CITY OF ALBUQUERQUE

RE: **9401 Black Farms Lane**
Grading Plan
Engineer's Stamp Date 12/5/17
Drainage File: C13D027C

Based on the information provided in your submittal received 12/5/17, the Grading Plan cannot be approved for Building Permit until the following are addressed:

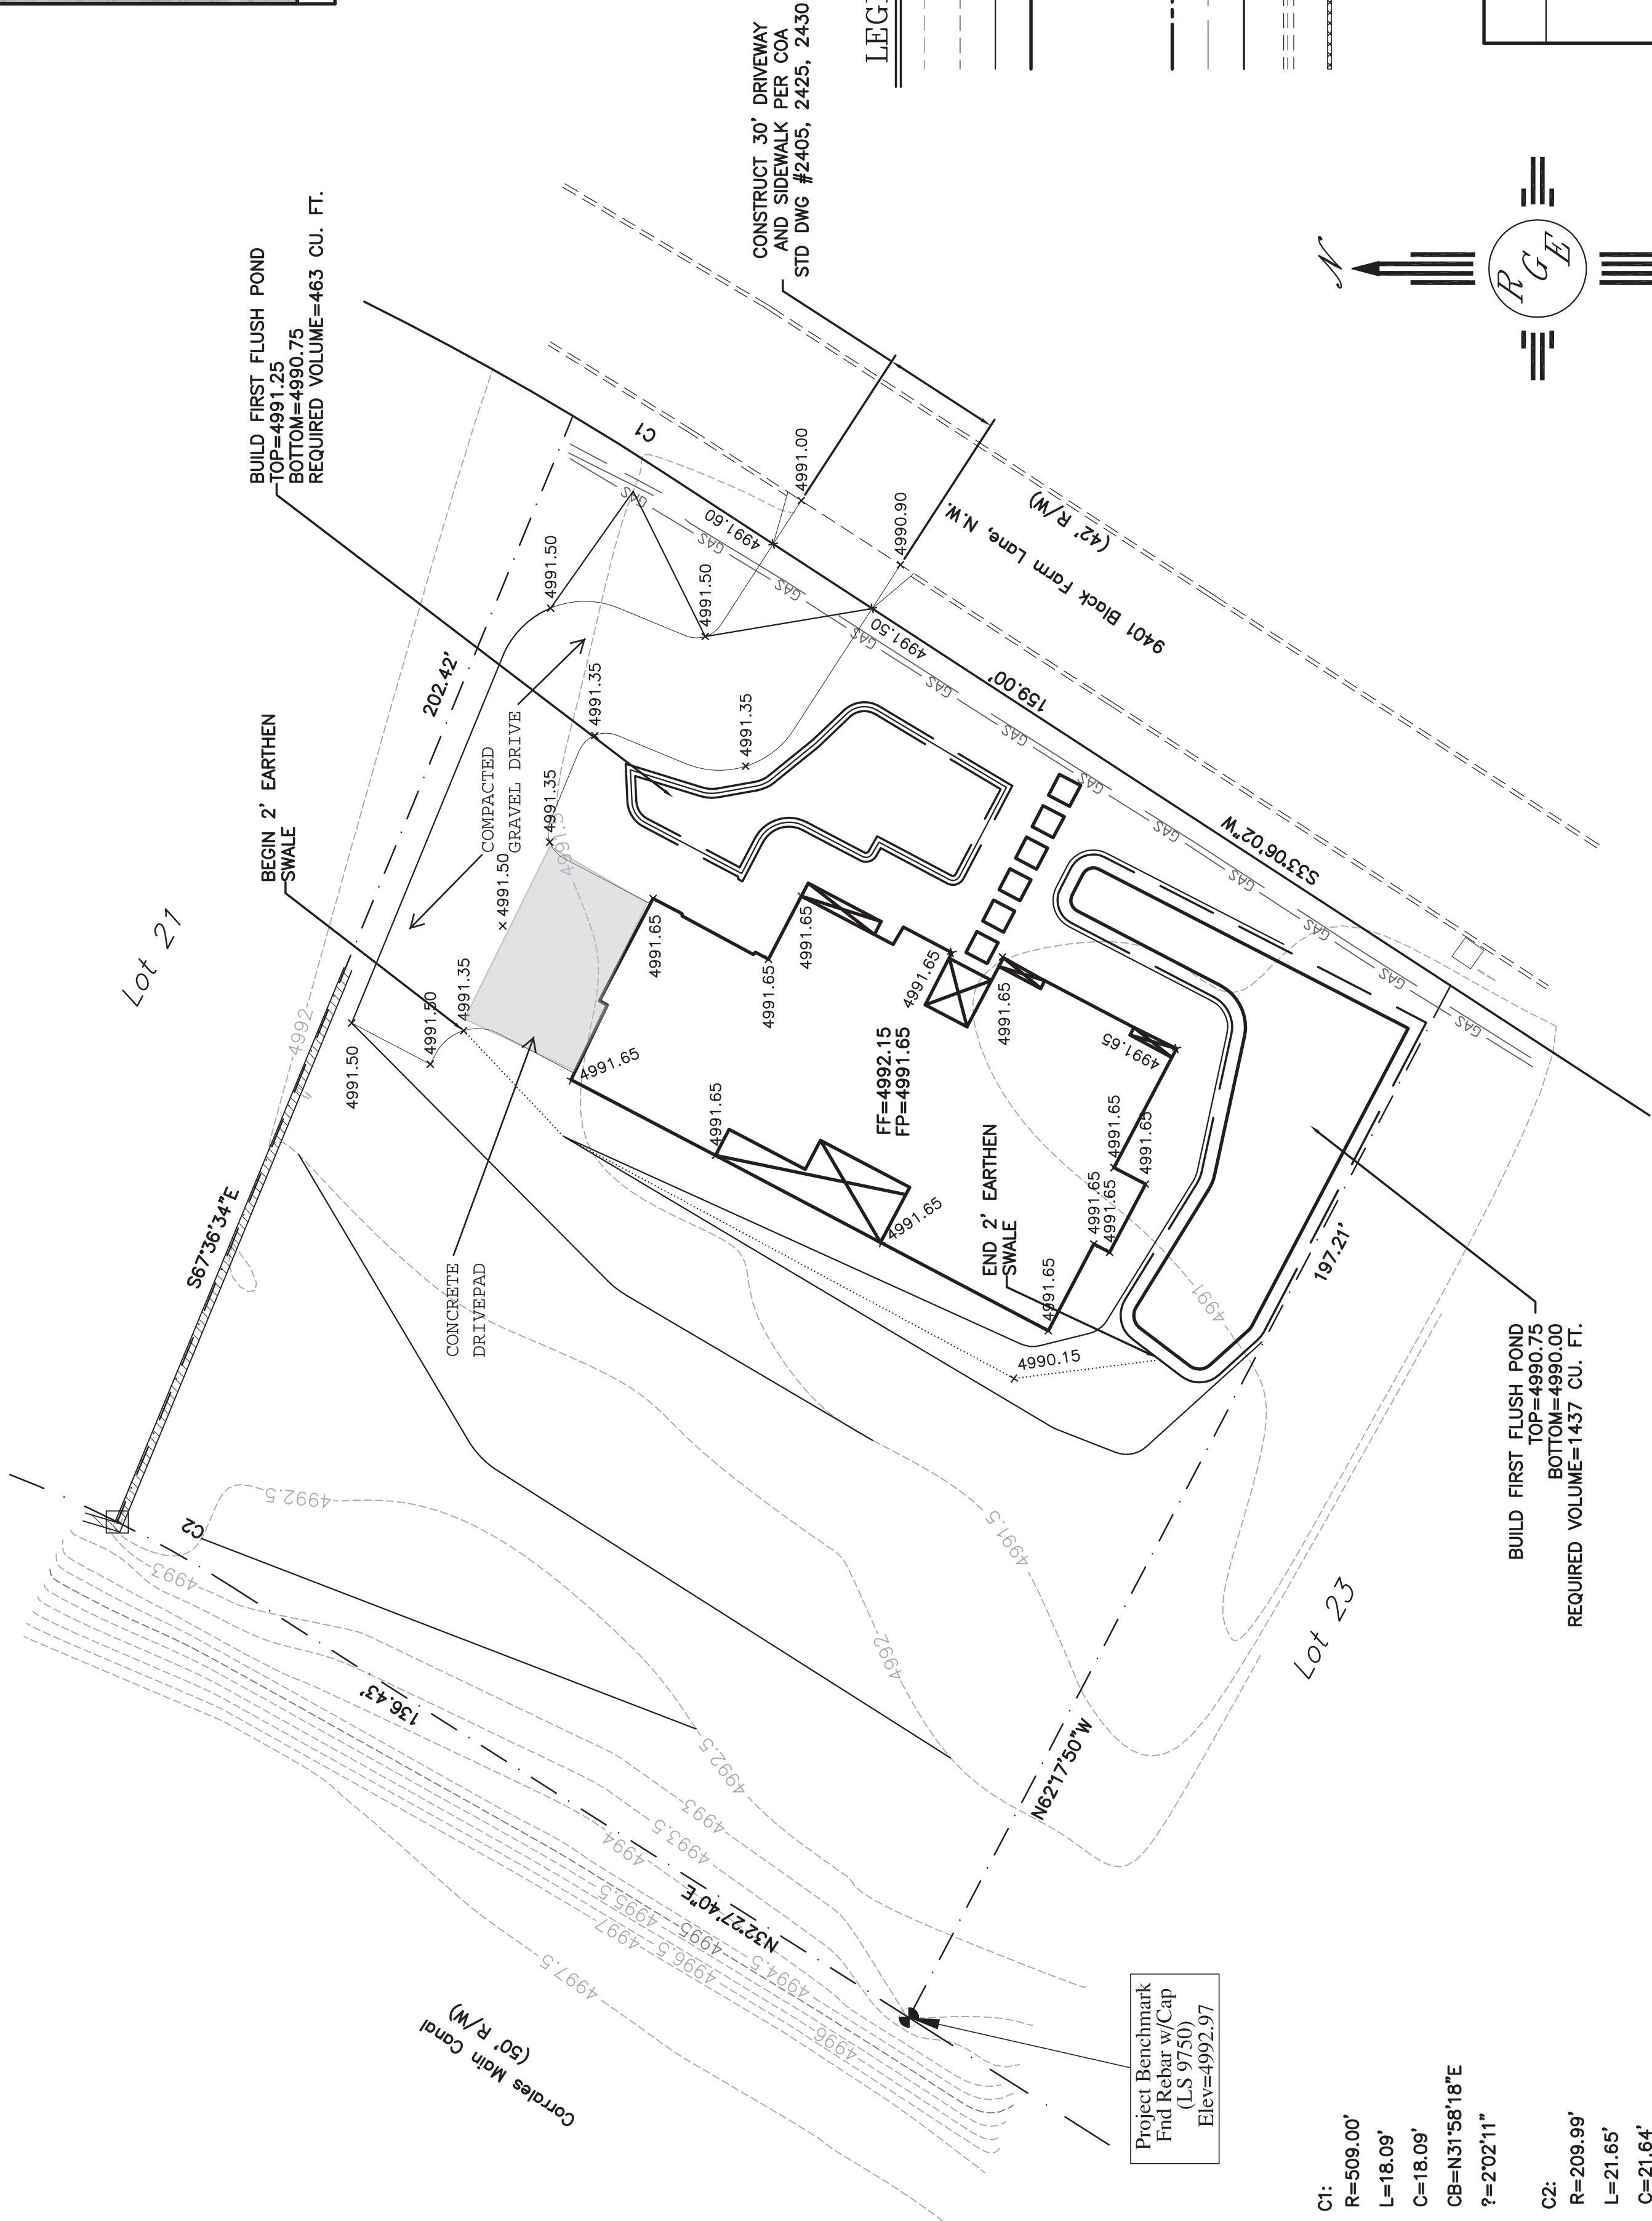
1. The approved Master Plan for Black Farms subdivision (C13D027) requires onsite retention of the developed 100-yr, 10-day volume and adherence to Valley grading criteria.
2. Ponds called for in the Master Plan were not built as part of the subdivision construction and will need to be built with each building permit.
3. It is recommended that the finished floor be elevated at least 1' above surrounding grades.
